**TOWN OF PORTOLA VALLEY
ARCHITECTURAL AND SITE CONTROL COMMISSION (ASCC)
Monday, July 28, 2014
7:30 PM – Regular ASCC Meeting
Historic Schoolhouse
765 Portola Road, Portola Valley, CA 94028**

4a. ARCHITECTURAL REVIEW AND REVISIONS TO PREVIOUS APPROVALS TO ALLOW PROPOSED SECOND STORY GUEST HOUSE ADDITION, 130 GOLDEN OAK DRIVE, ROSENTHAL/CARROLL

TO: Architectural and Site Control Commission (ASCC)
FROM: Karen Kristiansson, Interim Town Planner
DATE: July 24, 2014
RE: Architectural Review for Guest House Addition, at 130 Golden Oak, Rosenthal/Carroll

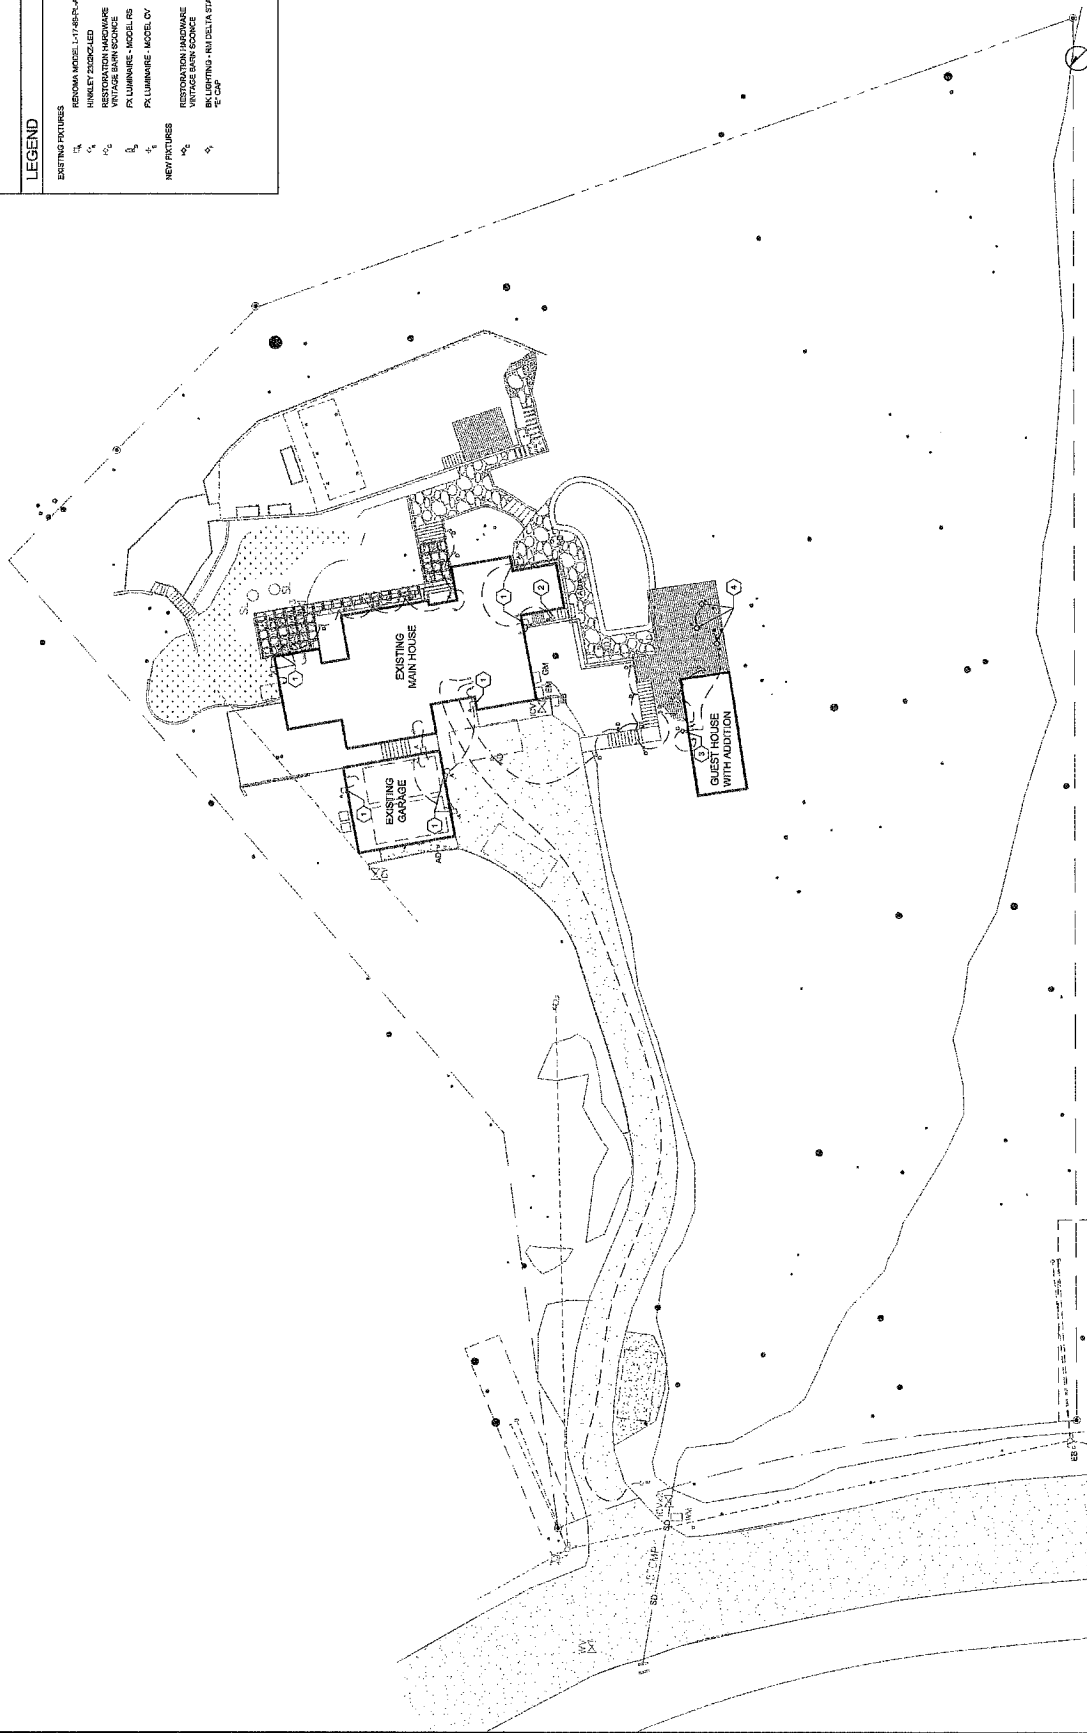
The plans also propose three new pendant lights to be hung from the oak trees that will be surrounded by the deck. Because Town policy limits exterior lighting to that which is needed for safety and specifically prohibits lighting in trees, this lighting should be removed from the plans.

1. The sconce lights on the guest house shall be separately and manually switched.
2. The pendant lights to be mounted in the trees as shown on Sheet EMP2.0 shall be removed, and there shall be no lighting in trees.
